**Cross Alameda Trail
Ralph Appezzato Memorial Parkway Improvements**

PROJECT NUMBER P.W. 03-18-11

ADDENDUM NO. 04

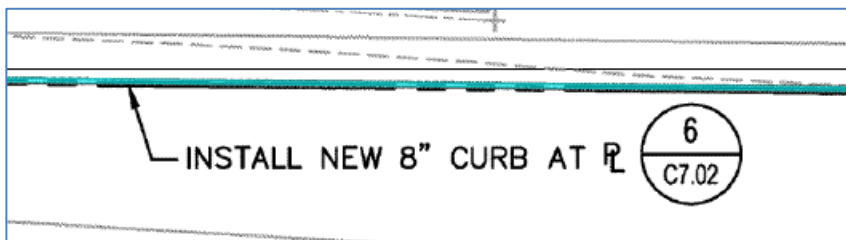
- 1) **Question:** On sheet C3.04 the Fire access path is called out as Detail 4/L-10, however that is tree staking and planting. Please clarify which detail to reference for the fire access? See snip below.

Answer: The fire access path is detailed on detail 6, sheet C7.01. To clarify this detail further, the section below the turf block should be 8" of recycled class 2 AB.

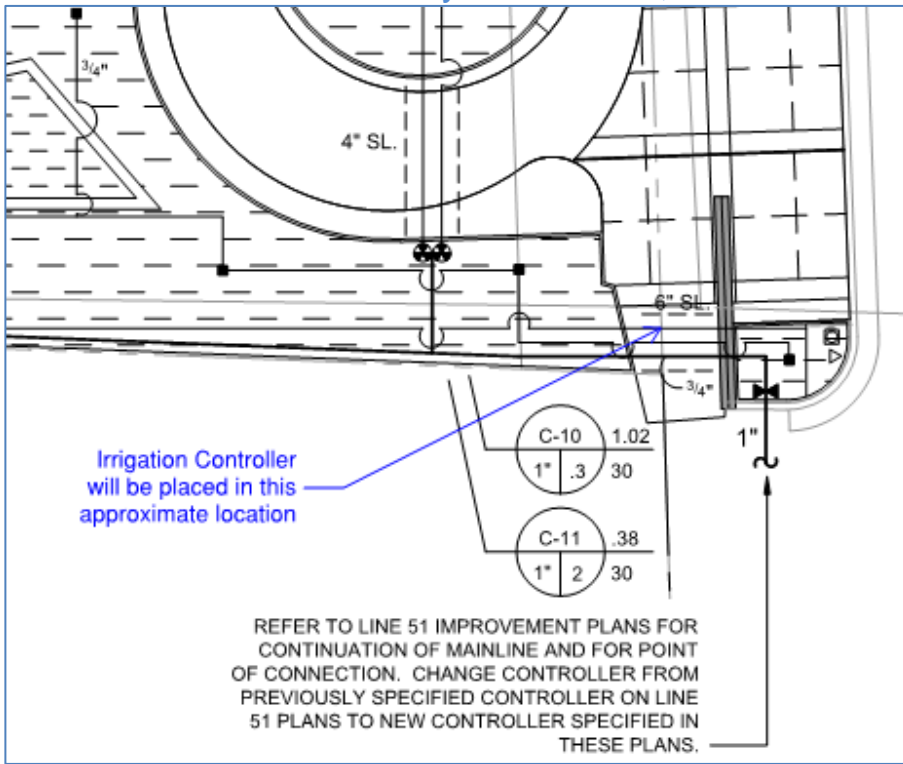
8) **Question:** On sheet L-5 sheet mulch is shown beneath the shrubs in tight proximity. Sheet L-6 does not indicate any sheet mulch beneath the shrubs. Please advise whether sheet L-5 or L-6 should be followed for the amount of sheet mulch at this section of the Cross Alameda Trail?

Answer: Follow Plan Sheet L-5 for the layout of Sheet Mulch throughout project_
